Solicitation #5000062410 – Furniture - Category 1, 2, 3, 5 and 6
Questions – Answers

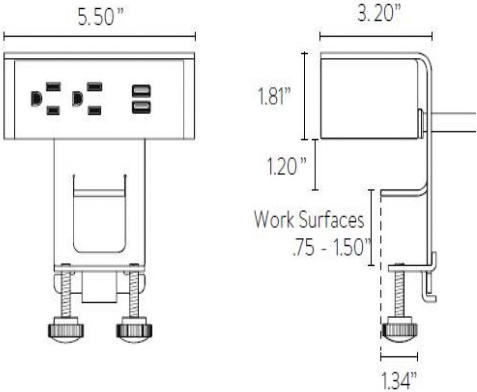
N*	Questions	Answers
1	<p>For Category 1, can you please indicate where on the plan can we find items on lines 3 and 4?</p>	 <p>See in red in the image above. These are all the work surfaces used as a support surface in all workstations</p>
2	<p>Would it be possible to get an extension for the submittal date of the bid?</p>	<p>Not possible.</p>
3	<p>Category 5 The Electrical module for surface 30 x 48 is that the module can be installed with a clip to aim on the surface as photo Or integrated into the surface?</p>  	<p>Both options are possible: Integrated or on the surface</p>

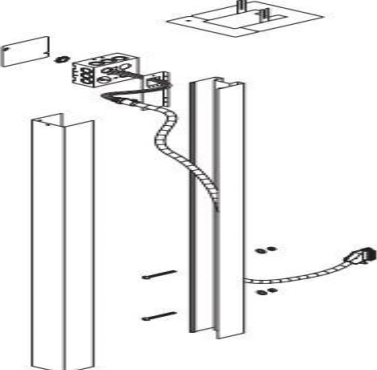
<p align="center">4</p>	<p>Category 5 Is this the Column you want, as pictured? He would like to know the height of the ceiling and where they should be installed on the plan</p> 	<p>Ceiling heights will be confirmed but it is at least 9 feet. One column is required per workstation island.</p> <p>The height of the ceilings is 12 feet 4 inches</p>
<p align="center">5</p>	<p>Cat 3, Item 3 - Please clarify what is meant by lock with or without a key? The GoCUID is for a keyed lock, do you mean an electronic lock 3LSL1HXXP18D18XHXS?</p>	<p>It can be a keyed or keyless lock. Keyless means electronic (combination)</p>
<p align="center">6</p>	<p>Cat 3, Items 1 & 2 - Please confirm the quantities as the quantities do not match the plan.</p>	<p>The quantities listed in the RFB are the ones to use.</p>
<p align="center">7</p>	<p>Will the shipping location be able to accommodate a 53 ft trailer? If not, what is the max. truck length the location is able to accommodate?</p>	<p>Truck over 35ft is not recommended for deliveries.</p>
